ISSUE:	Certificate of Appropriateness for alterations
APPLICANT:	Karel and Ashley Malinovsky
LOCATION:	Old and Historic Alexandria District 1315 Prince Street
ZONE:	RM/Residential Townhouse Zone

The applicant requests a Certificate of Appropriateness to replace a rear concrete parking pad with pavers, at 1315 Prince Street.

Figure 2- View from Commerce Street

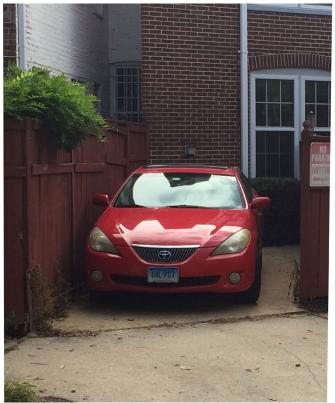
The rear of the property faces Commerce Street. The proposed parking area is therefore fully visible from a public right-of-way (Figure 2).

Staff has no objection to the replacement of the existing concrete parking pad with pavers. The building was built in 1989 and the use of pavers on parking pads were largely used at that time. Furthermore, the applicant is proposing the same material as the next-door neighbor's which will visually unify and harmonize the properties on the block face.

Therefore, staff recommends approval of the Certificate of Appropriateness for alterations as submitted.
